# Route 5/Virginia Capital Trail

## Pedestrian Safety and Operational Assessment

### Henrico County, Virginia

**July 8, 2016**

# WOOD MILL AREA

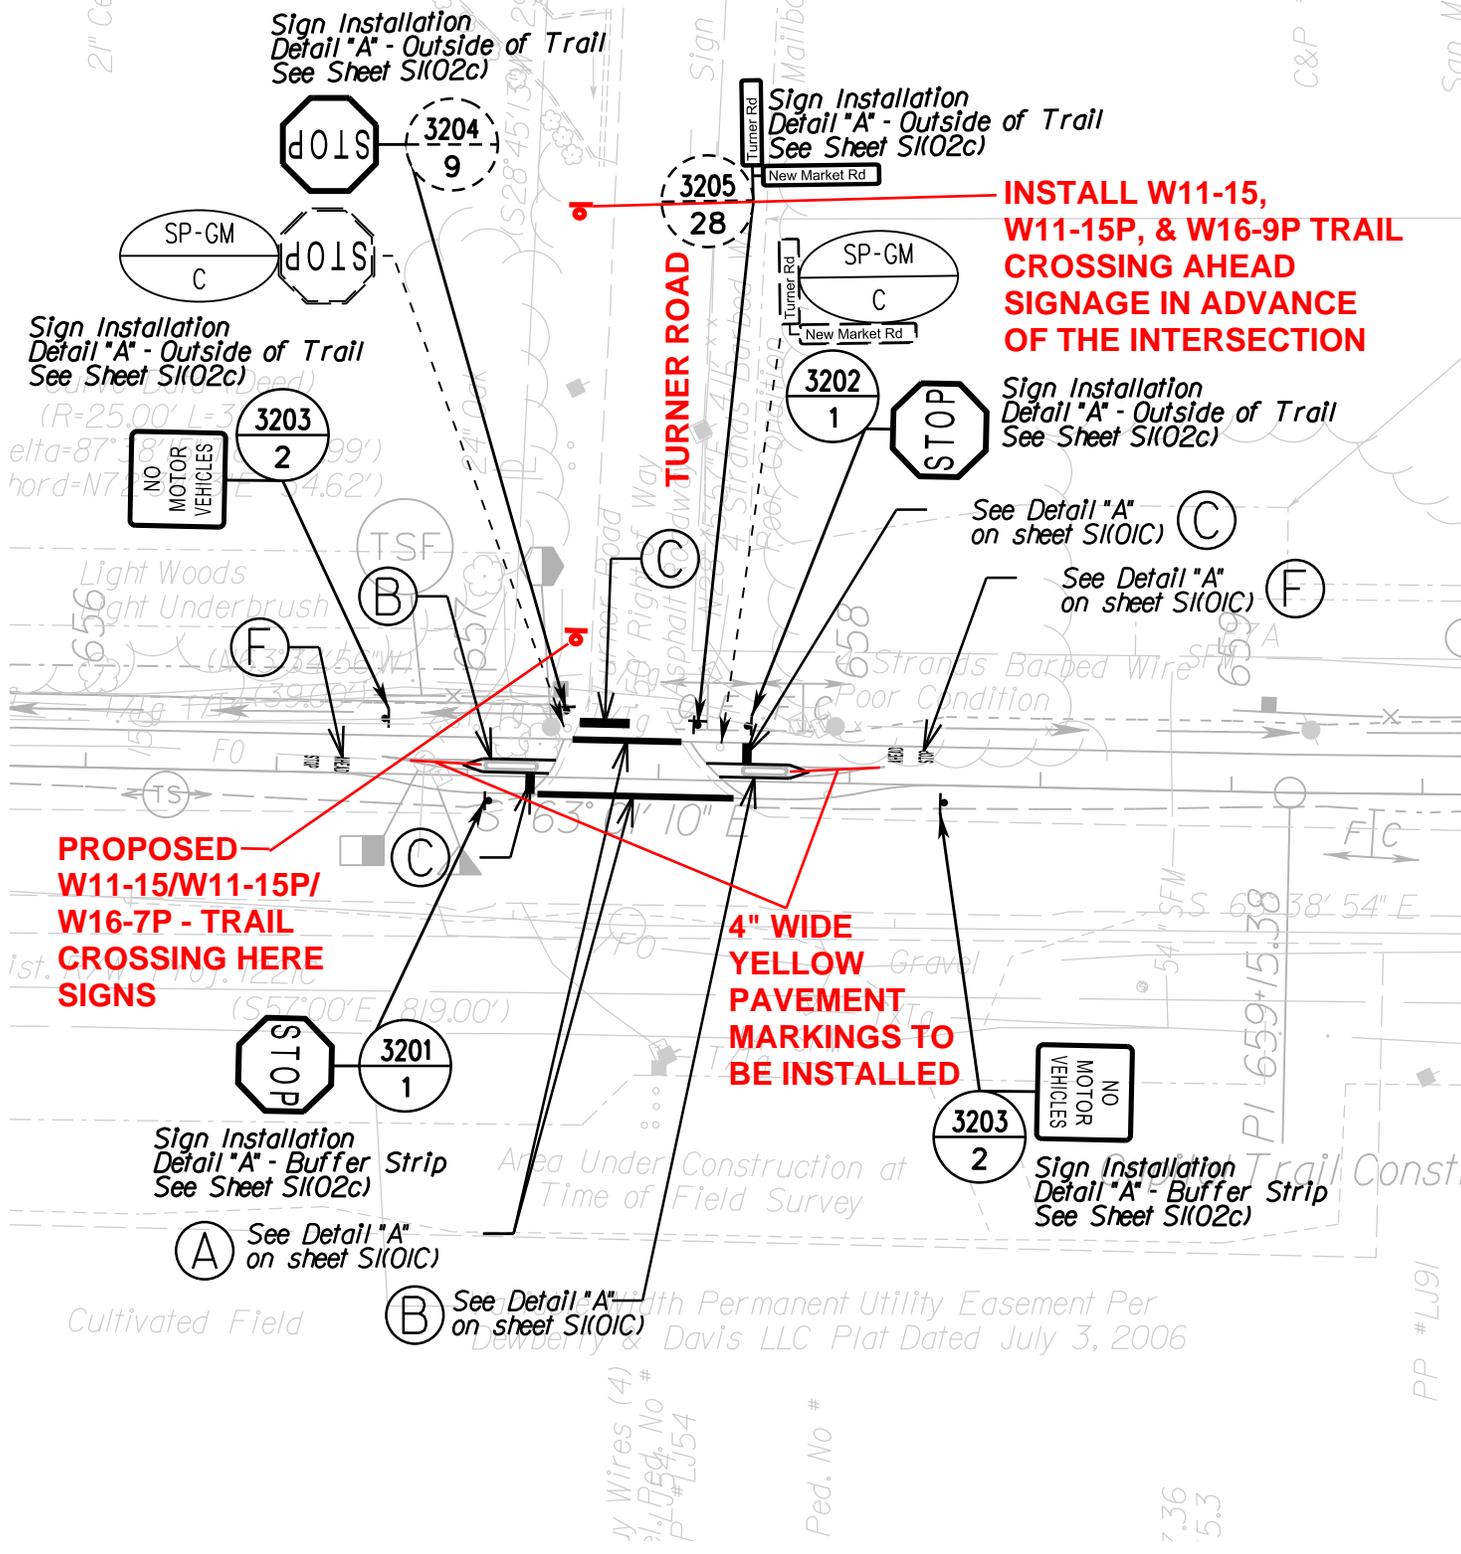
**EDGE OF TRAIL  
NOT PROPER  
DISTANCE OFF  
EDGE OF  
PAVEMENT**

**REMOVE  
BOLLARDS AND  
REPLACE WITH  
SAME  
INTERSECTION  
TREATMENT AS  
ALL OTHER  
INTERSECTIONS**

# NEW MARKET HEIGHTS LN AREA

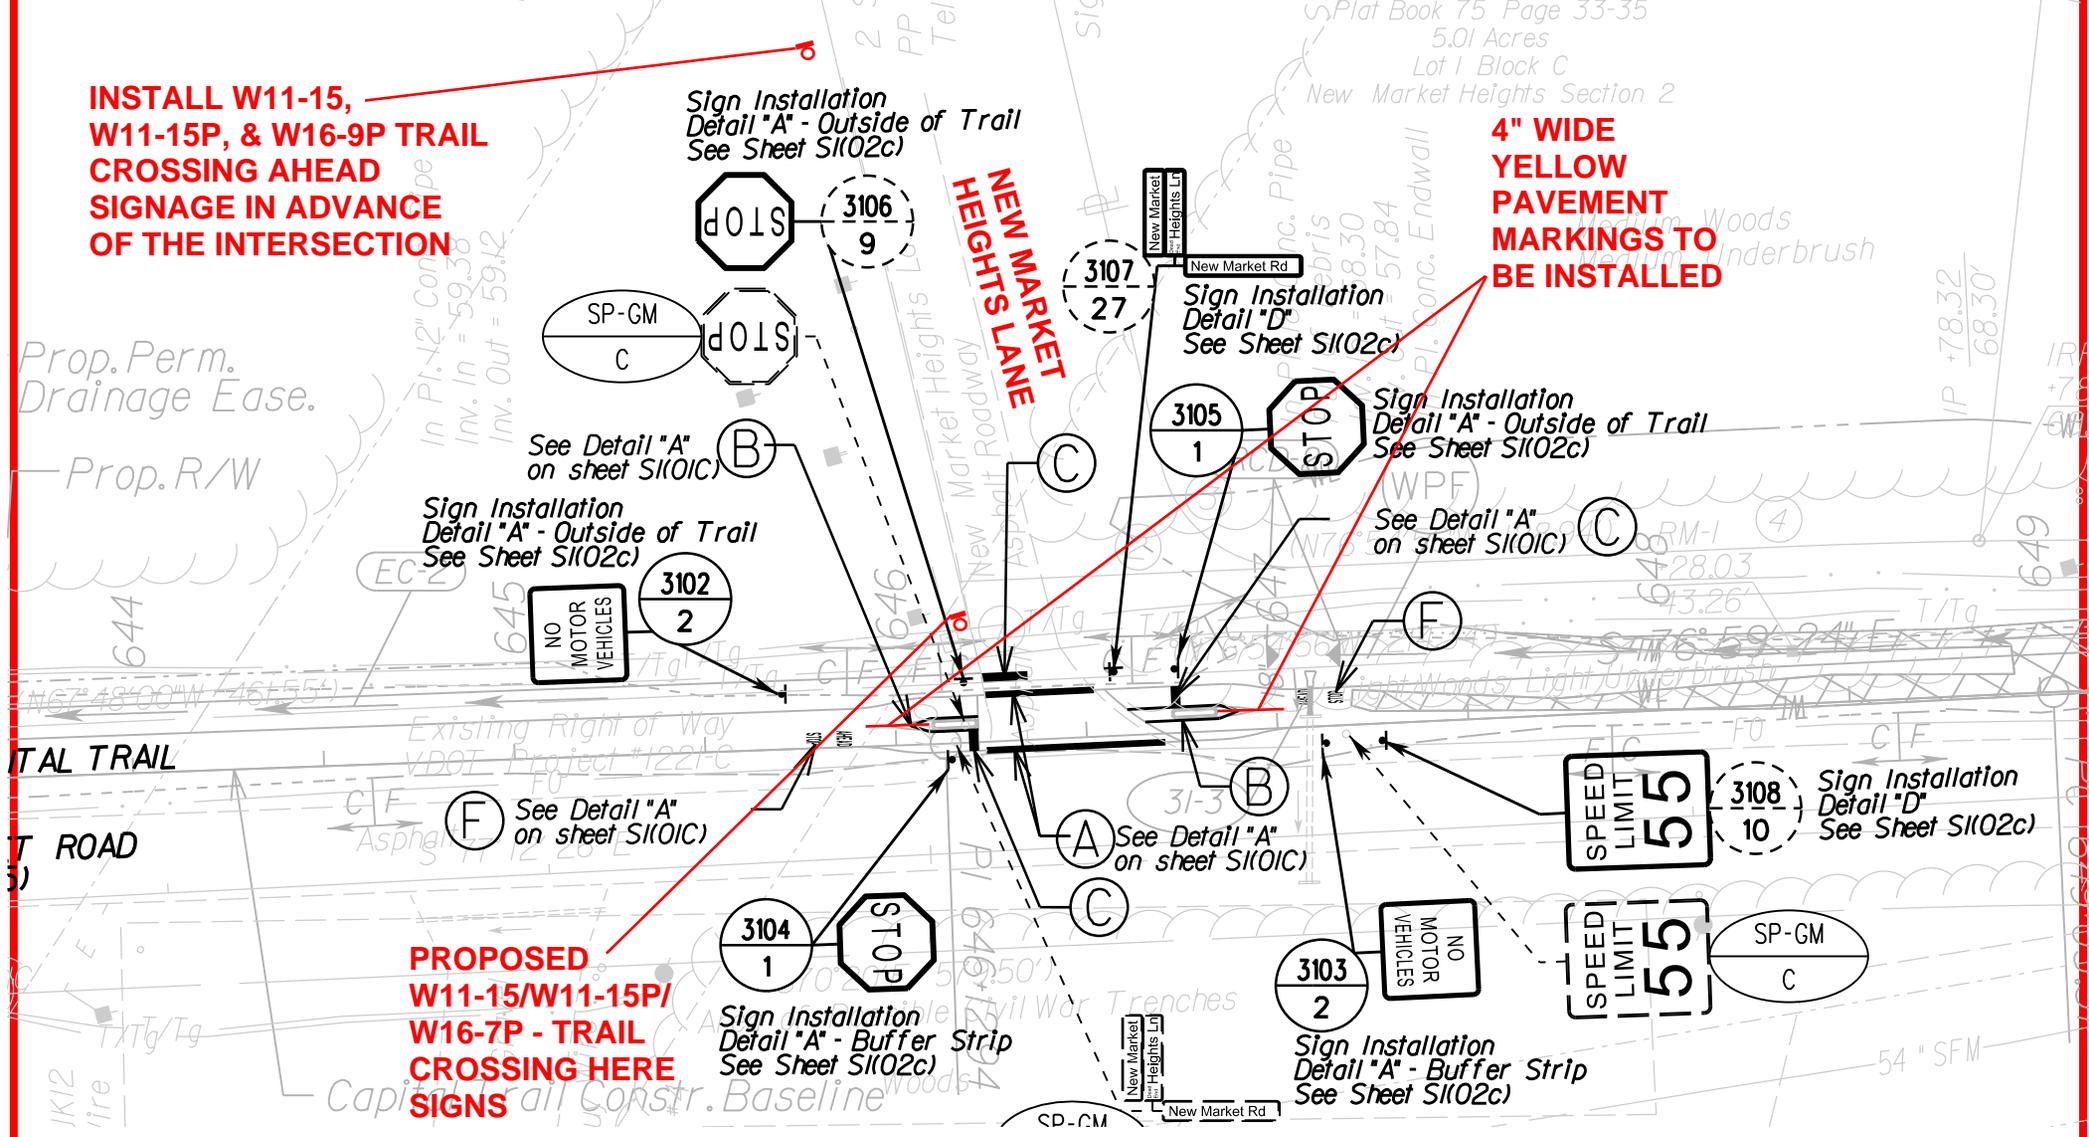
**INSTALL W11-15, W11-15P, & W16-9P TRAIL CROSSING AHEAD SIGNAGE IN ADVANCE OF THE INTERSECTION**

**4" WIDE YELLOW PAVEMENT MARKINGS TO BE INSTALLED**

# BRIDGE B-611 AREA

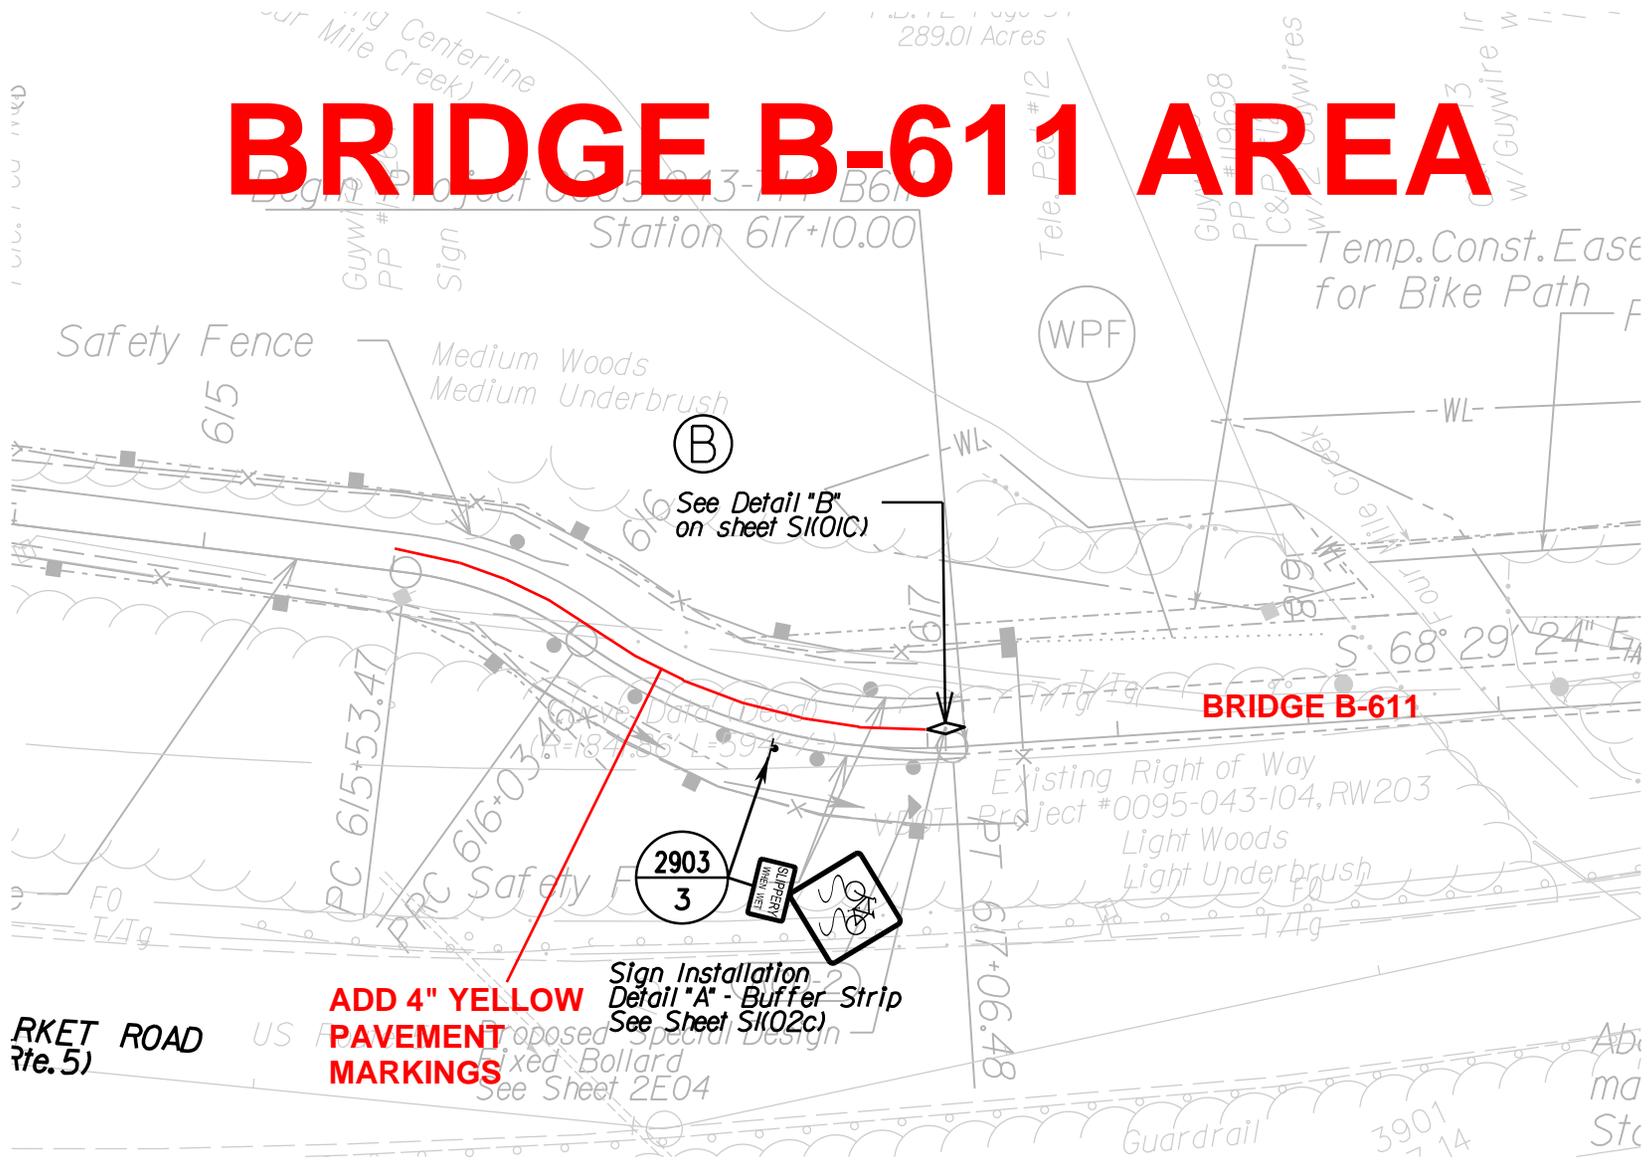
**ADD 4" YELLOW PAVEMENT MARKINGS**  
Sign Installation  
Detail "A" - Buffer Strip  
See Sheet S1(02c)

# LONG BRIDGE ROAD AREA

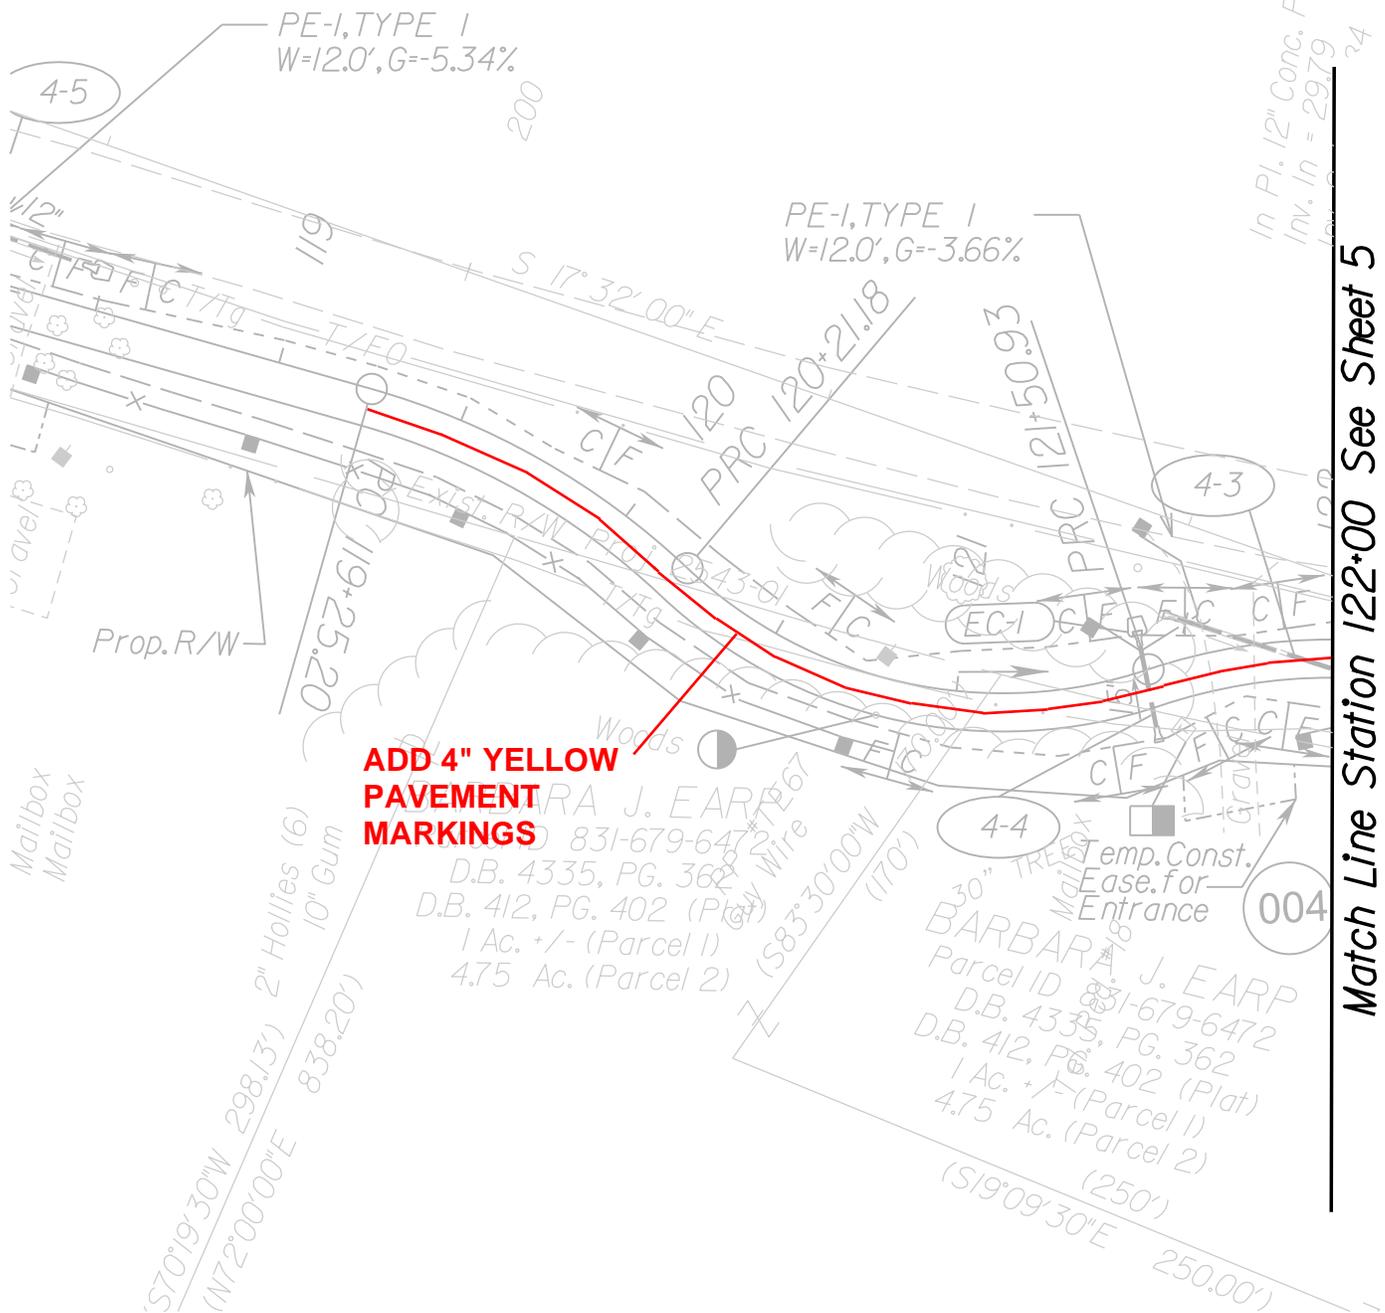
**ADD 4" YELLOW  
PAVEMENT  
MARKINGS**

# PCN, LLC AREA

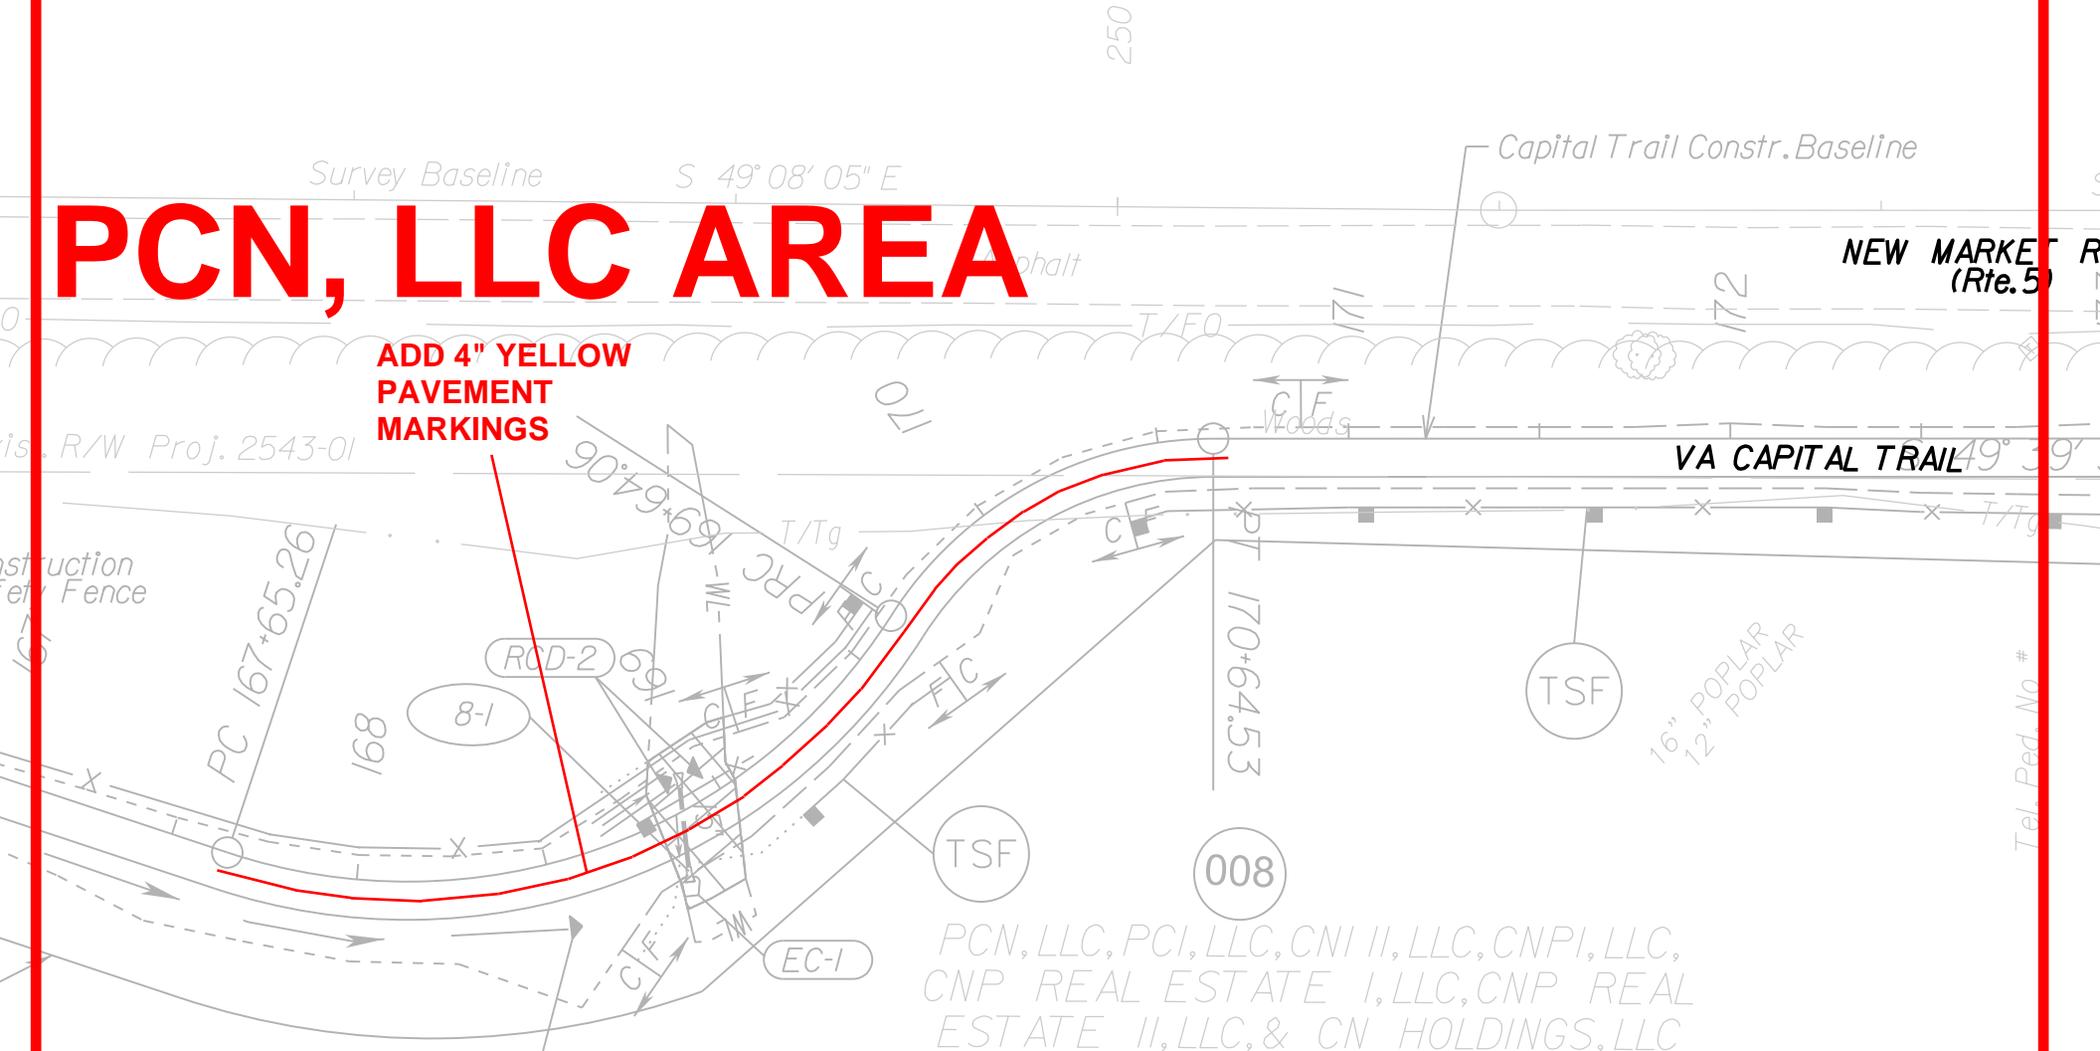
**ADD 4" YELLOW  
PAVEMENT  
MARKINGS**
